11.1.16 Proposed Concrete Batching Plant - Amended Plans to Approved Application - Section 31 SAT Reconsideration

Location: Lot 2, 277-279 Collier Road, Bayswater
Applicant: WA Limestone
Owner: Ransberg Pty Ltd
Officer: Director Planning and Development Services
Refer: Item 11.1.10: OCM 25.8.2015
 Item 11.1.10: OCM 26.5.2015
 Item 11.1.12: OCM 23.7.2013
 Item 11.1.10: OCM 23.4.2013
 Item 15.1.3: OCM 22.11.2011
 Item 11.1.12: OCM 28.6.2011

**Proposed concrete batching plant - WA Premix
SAT mediation - updated advice on environmental risks**

Plans for Development - Amended

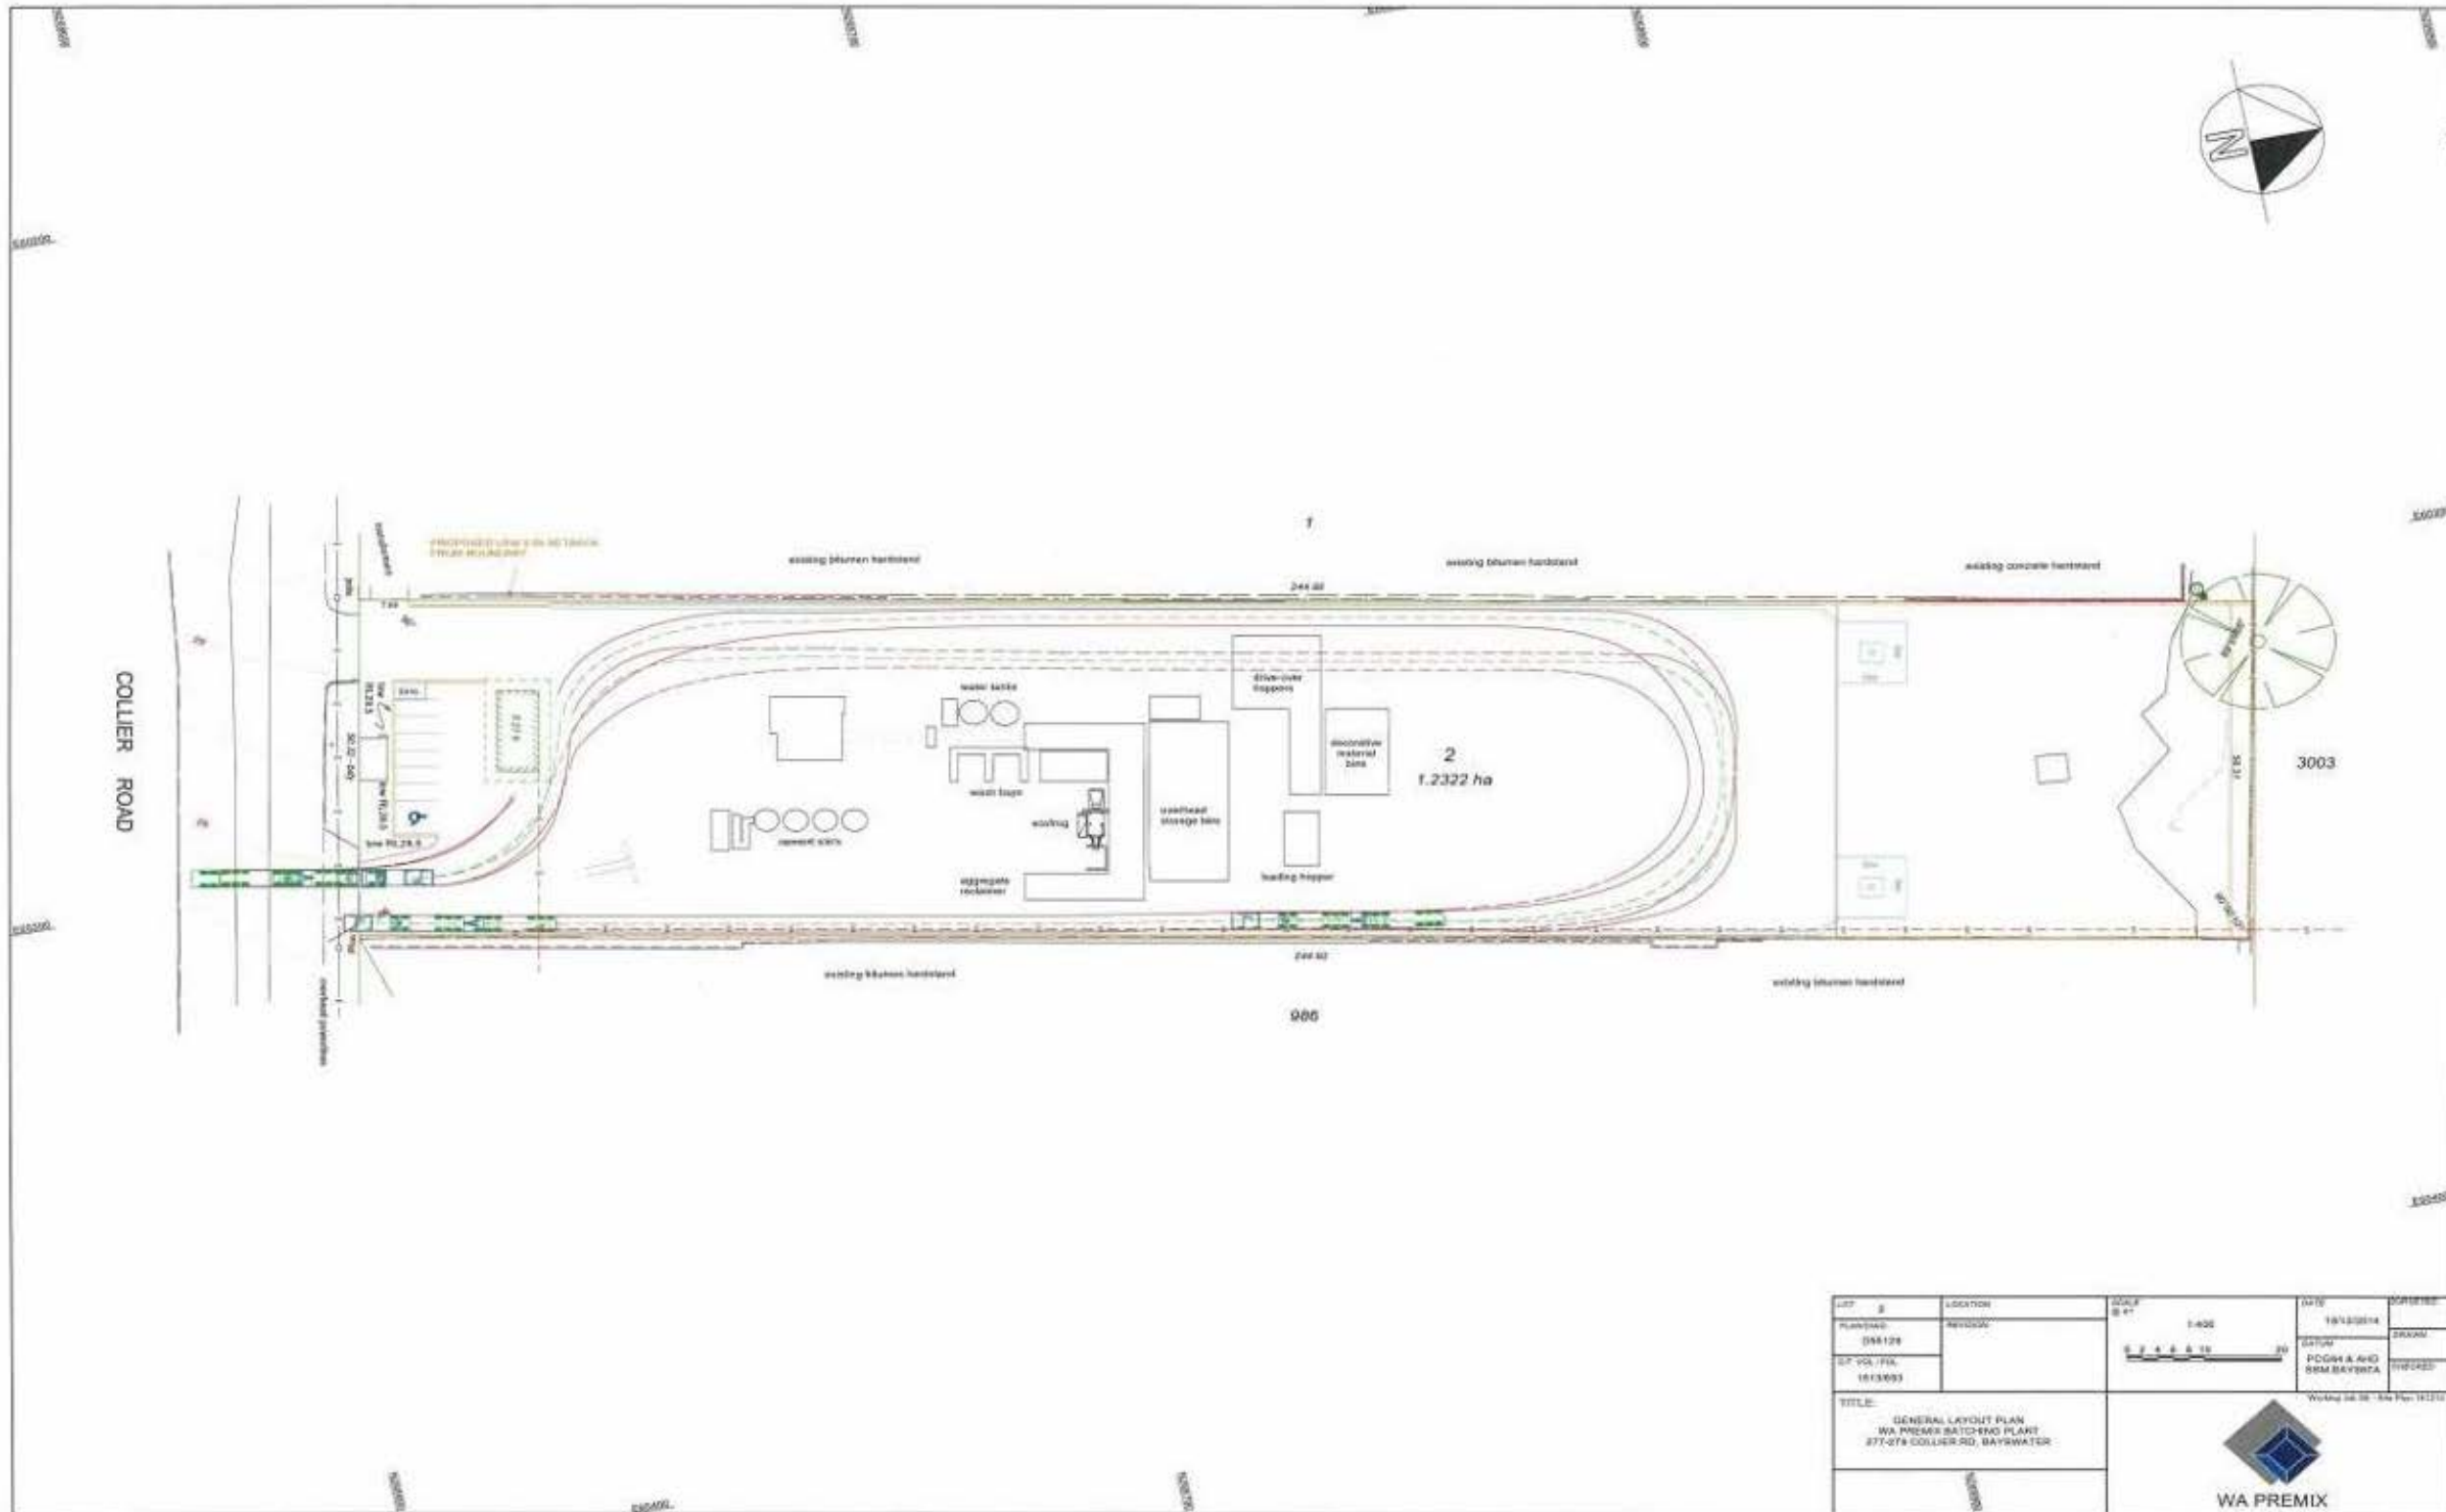
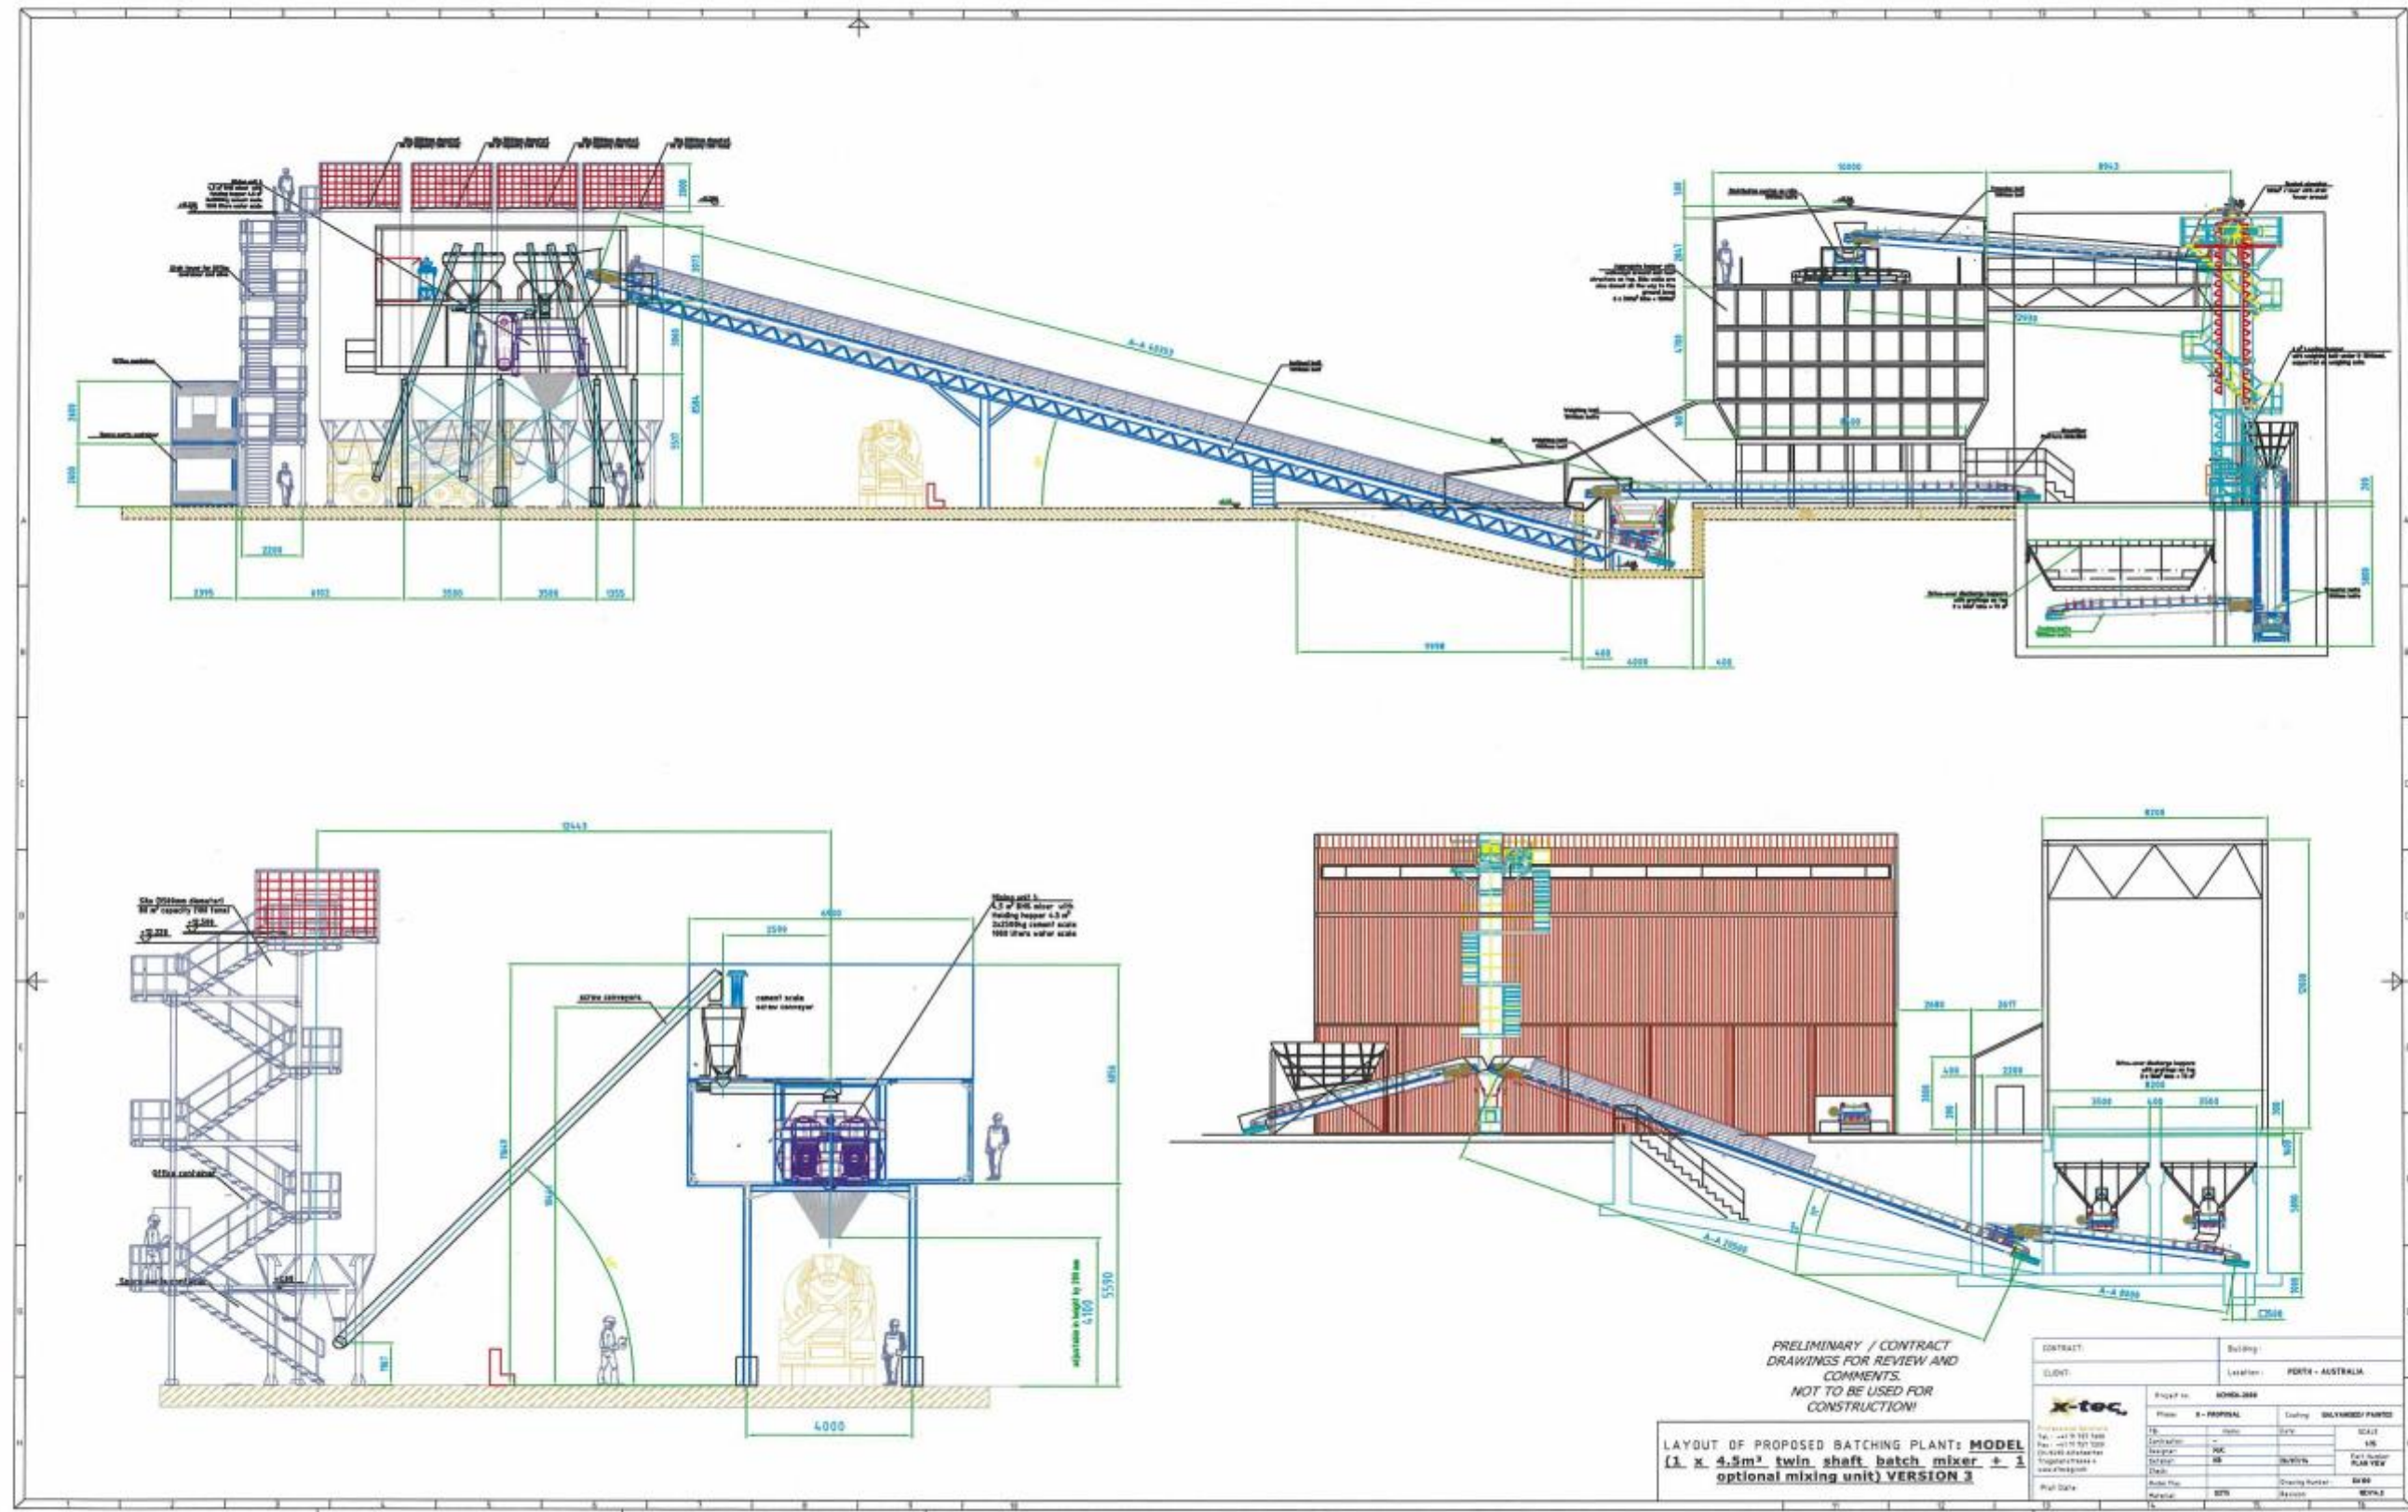
The applicant has advised that the amended application proposes to enclose the plant with the exception of the wash bay, and that the wash bay will not generate dust (**Attachment 7**).

The City's environmental consultant considers that amended proposal will have a lesser environmental impact than the plant originally approved by the SAT. The amended plans illustrate the wet-mix plant will be mostly enclosed and by this, will substantially decrease risks of noise and dust emissions. The environmental report supplied by the applicant states:

The proposed alterations are considered to improve the applicant's ability to manage dust and noise emissions from the site, given the plant will be mostly enclosed. The amended plans will essentially eliminate the consistent use of front-end loaders which is considered to substantially lower any potential noise impacts.

That Council, in consideration of the additional information provided by the applicant and environmental consultant, approves the revised plans dated 29 January 2015 in relation to the planning approval granted by the State Administrative Tribunal on 15 July 2015 for the proposed concrete batching plant at Lot 2, Nos. 277-279 Collier Road, Bayswater, subject to all conditions and requirements detailed on the previous approval granted 15 July 2014 and the following amended and additional planning conditions:
